MANKATO PLANNING COMMISSION
Regular Meeting July 22, 2026 - 6:00 p.m.
Intergovernmental Center
Council Chambers

Request of ISG, on behalf of Mankato Surgery Center, for a preliminary and final plat review of Mankato Clinic Fifth Addition; for an amended planned unit development, PUD, to allow for a structure expansion and replatting of the existing planned unit development; and for a certificate of design compliance for a property located in the Highway Gateway Overlay District for an addition to an existing structure. The subject property is described as Lot 1, Block 1, Mankato Clinic Third Addition, and Lot 1, Block 1, Mankato Clinic Fourth Addition, City of Mankato, Blue Earth County (1411 Premier Drive).

Request of Rice Companies, on behalf of the owner Kohlmeyer Hagen Law, for a certificate of design compliance for a new, approximately 9,360 square foot structure to be located in the Highway Gateway Overlay District. The subject property is described as Lot 1, Block 1, Alexia Subdivision (Blue Earth County PID R010909126033).

Site Plan Review Comments

C3-10

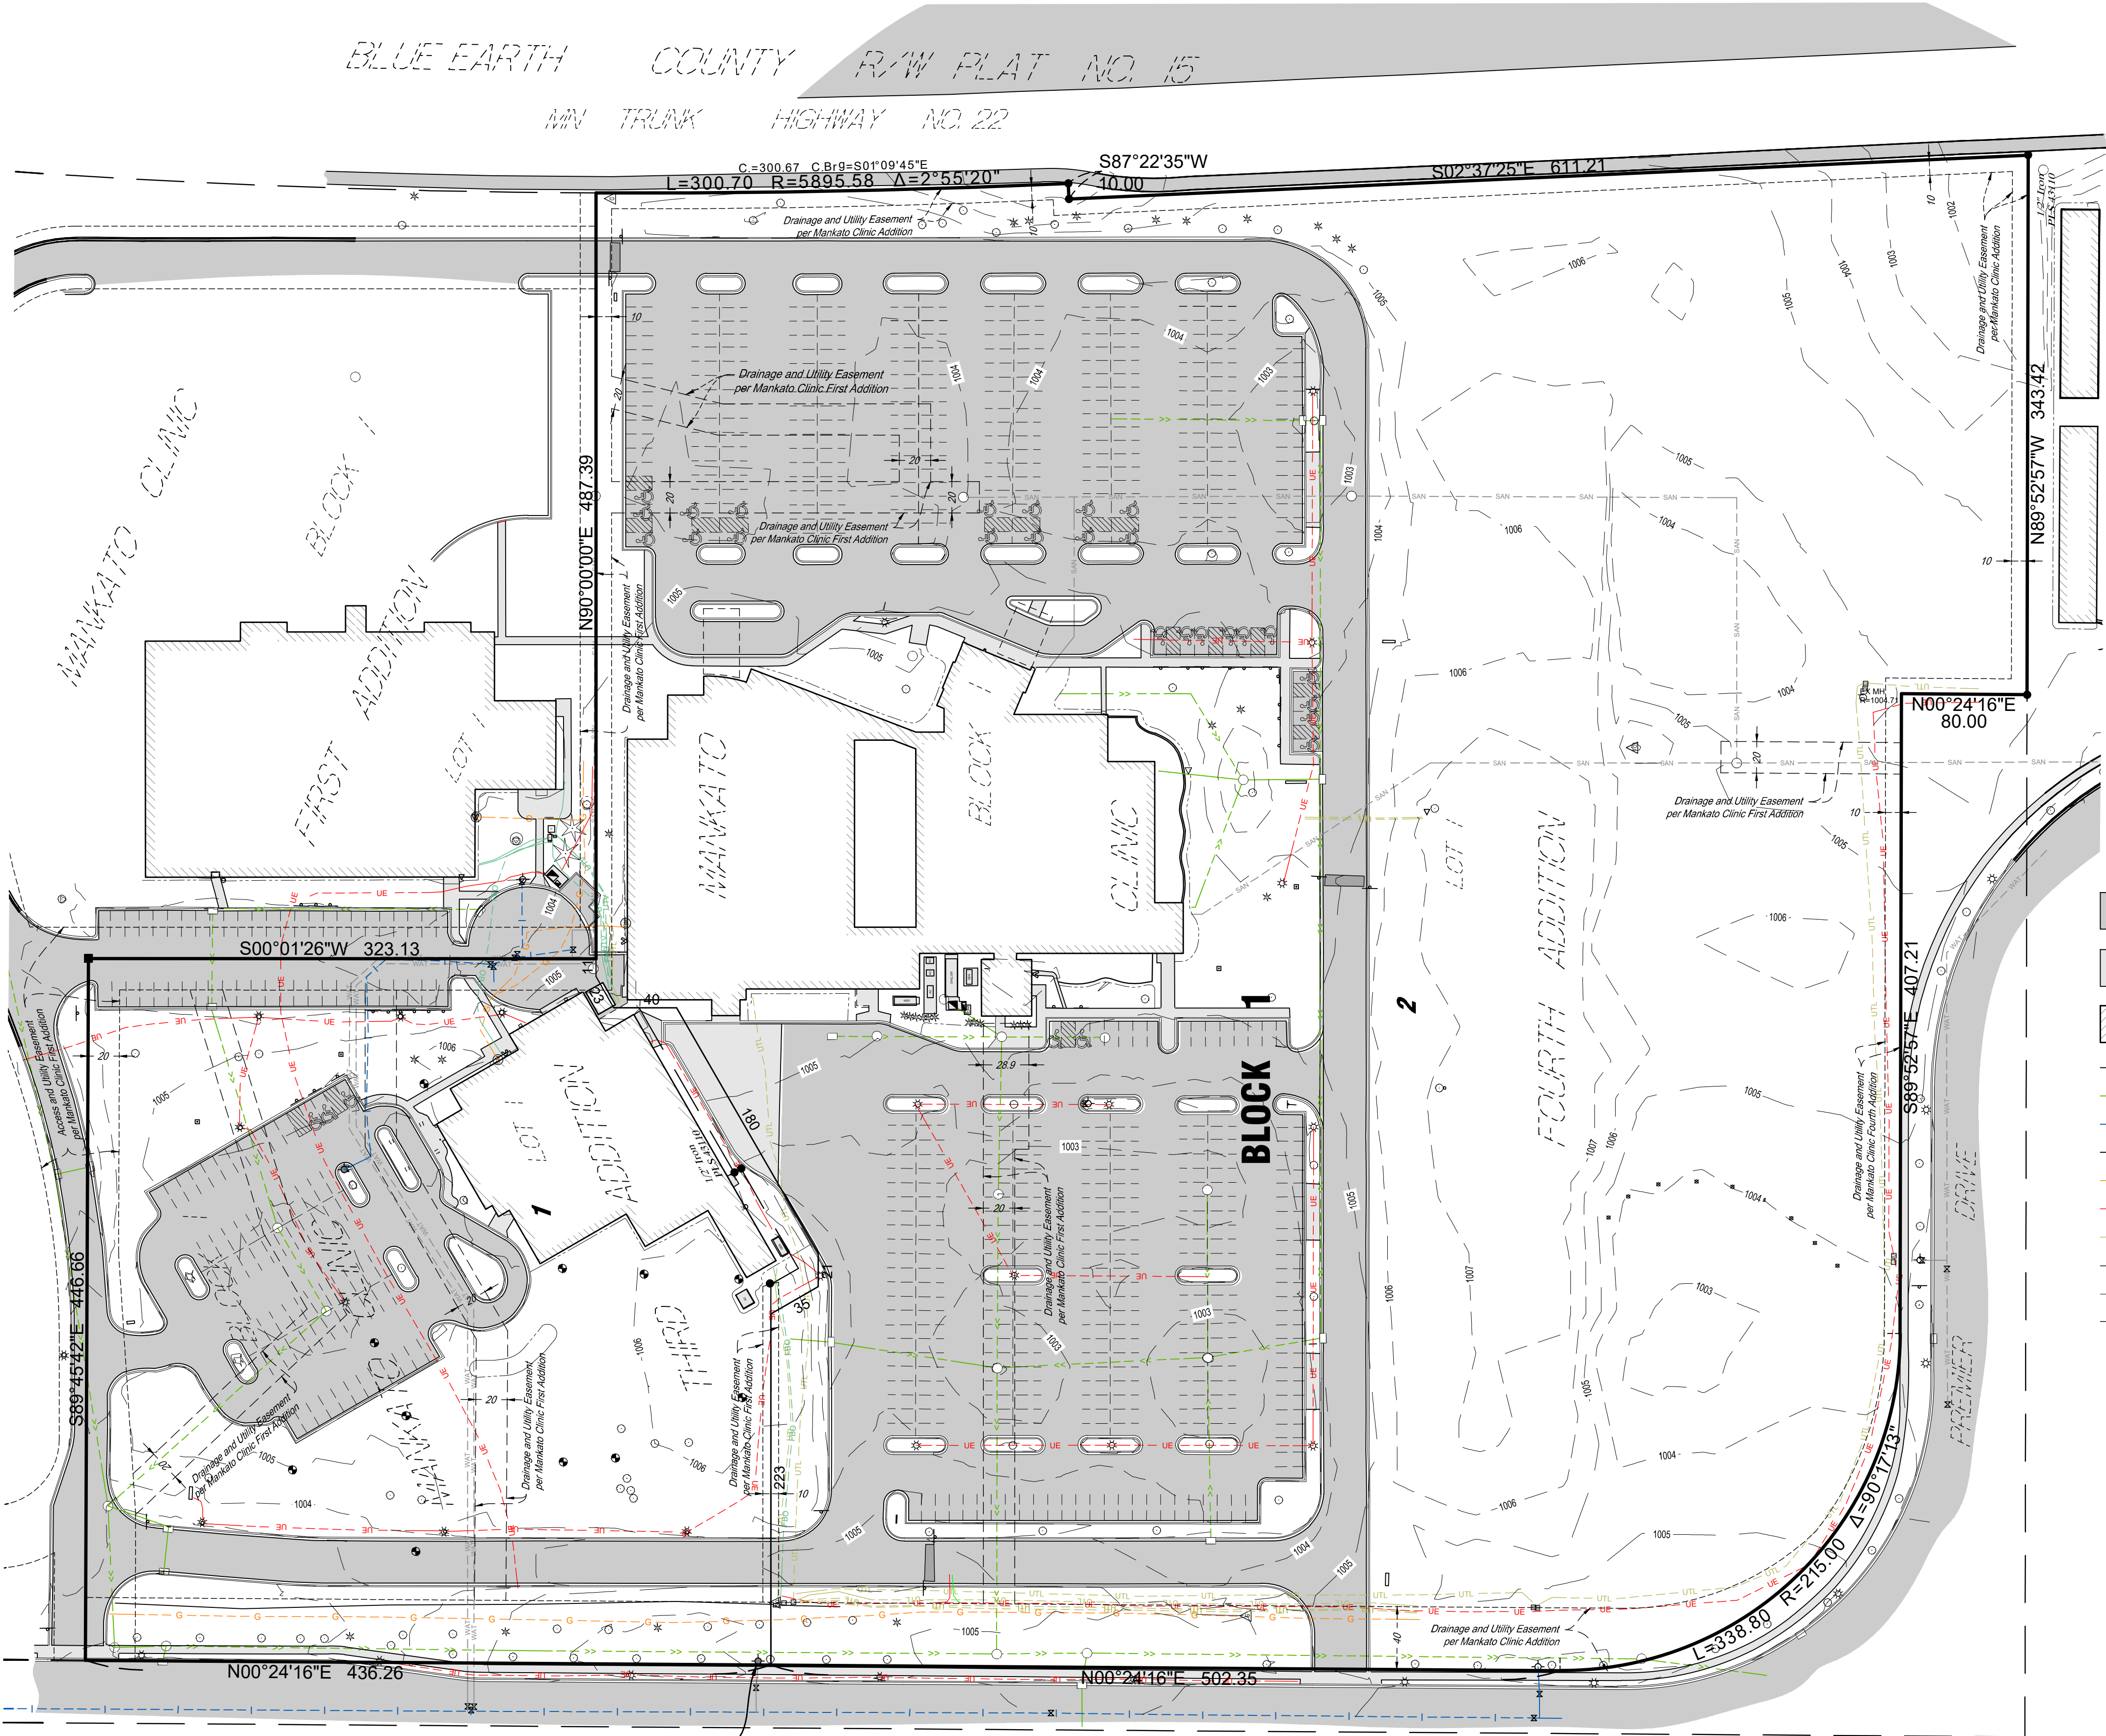
- l. Sheet C3-10 – Proposed Storm Pipes and Drainage Structure sizes and types shall be noted in the plan sheet.

- l. Sheet C3-10 – Proposed Storm Pipes and Drainage Structure sizes and types shall be noted in the plan sheet. *Applicant: Revised as requested.*
- m. Applicant shall confirm water is not trapped in parking addition along the east curb line on the north side, near ST-5. As depicted, curb line currently captures water. *Applicant: Water is not trapped in that area. The curb is graded to drain to ST-3.*

MECHANICAL /AIR GAS SCREEN

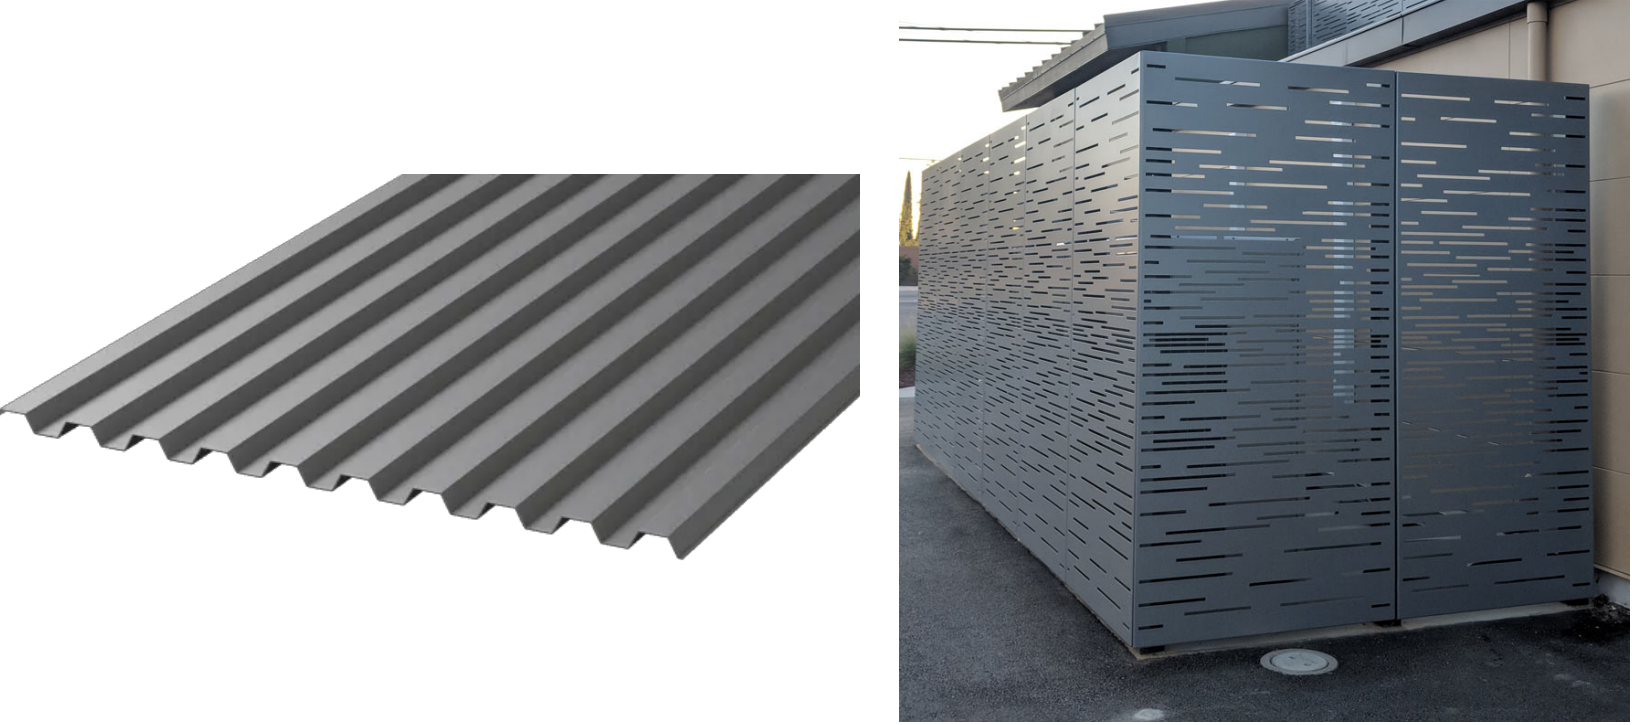
- c. Applicant shall clarify the proposed screening plan for the bulk oxygen tanks. *Applicant: The tanks will be screened with materials and landscaping that are consistent with the project architecture and applicable City of Mankato requirements to minimize visibility from adjacent public rights-of-way and neighboring properties. The screen shall be constructed of Bok Modern mechanical screen fence with reveal pattern B21.1.*

The new bulk oxygen tank located in the cul-de-sac turn around will feature Bok Modern screen panels in a gray color.

ISG Response: The tanks will be screened with materials and landscaping that are consistent with the project architecture and applicable City of Mankato requirements to minimize visibility from adjacent public rights-of-way and neighboring properties. The screen shall be constructed of Bok Modern mechanical screen fence with reveal pattern B21.1.

SHEET
C4.01

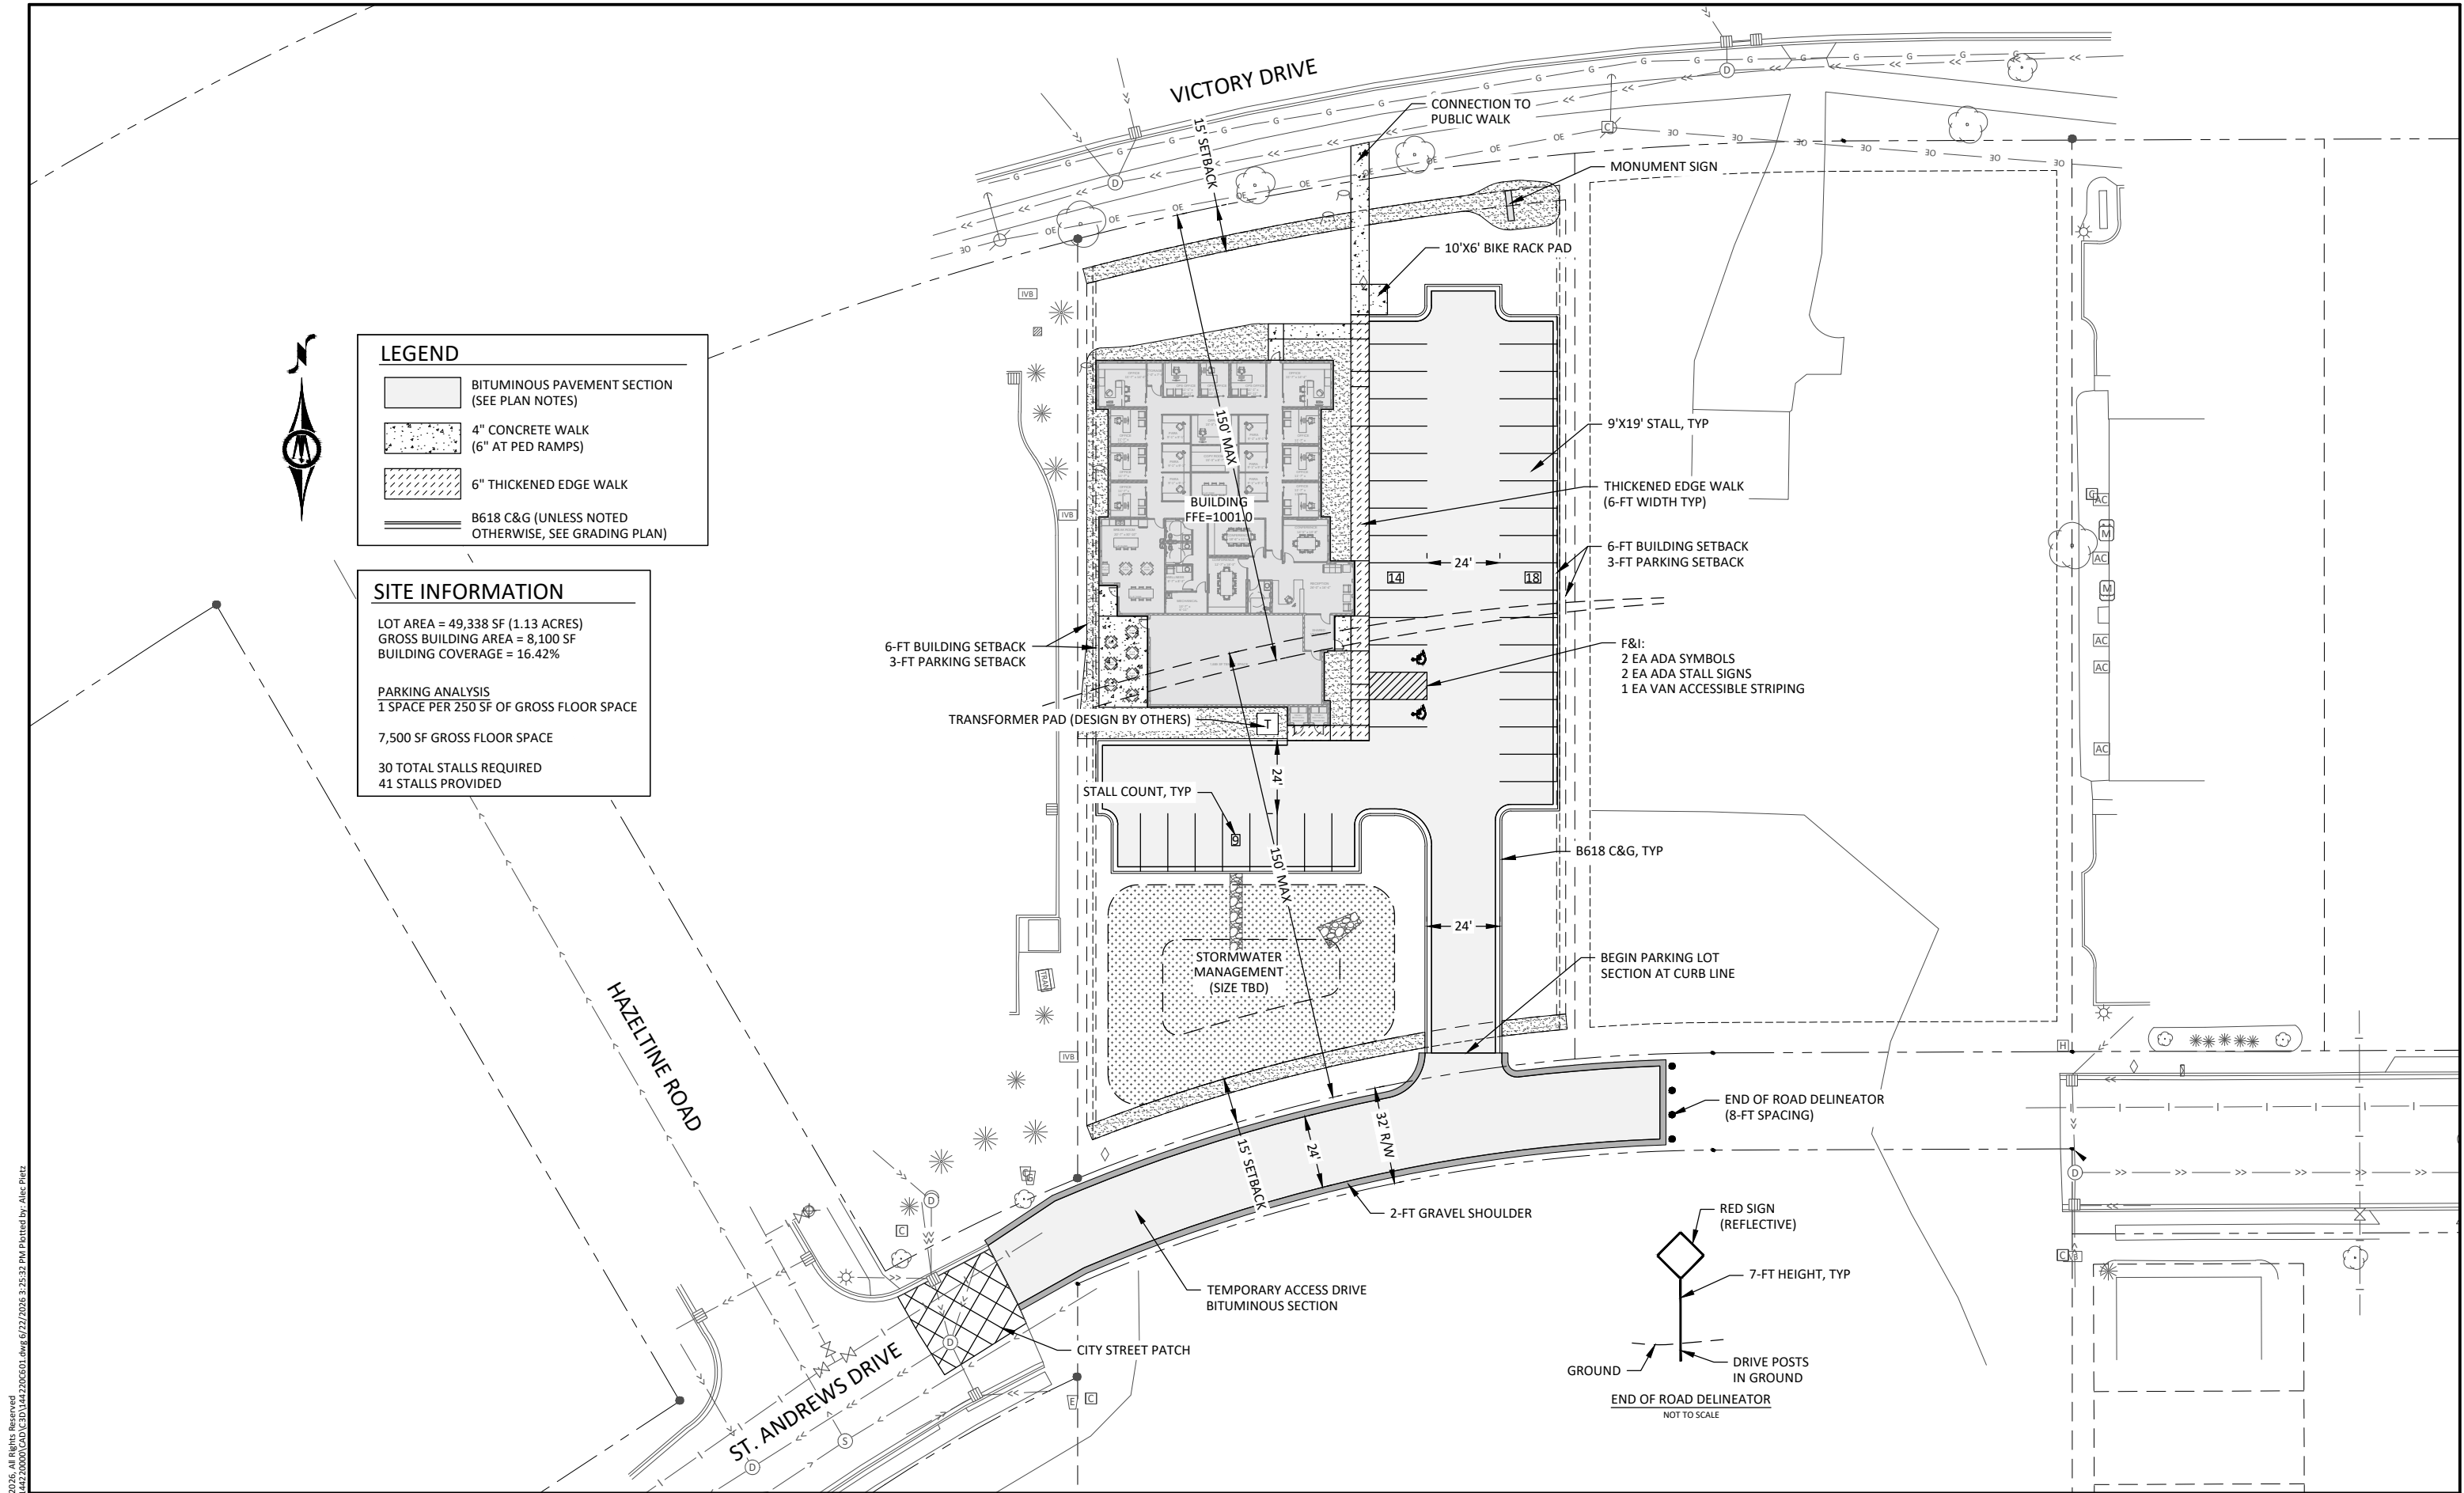
- i. Sheet C1.01 - Missing City Street Patch Bituminous Pavement Section. *Applicant: "Acknowledged, to be included in final civil plans."*
- j. Sheet C4.01 - New precast concrete storm manhole shall be provided at storm connection point in St. Andrews Drive. *Applicant: "Acknowledged, to be included in final civil plans."*

- k. Sheet C4.01 - Add a note where the 2" Curb stop is located. *Applicant: "This is noted on C5.01 but will be added to this sheet too."*
- l. Sheet C4.01 - Size precast concrete drainage structure A-1 to accept future 24" RCP Pipe to be core drilled connected in the future. *Applicant: "Noted, the future pipe shown on C4.01 will also be noted as 24-inch."*

- j. Acknowledged, to be included in final civil plans.
- k. This is noted on C5.01 but will be added to this sheet too.
- l. Noted, the future pipe shown on C4.01 will also be noted as 24-inch.
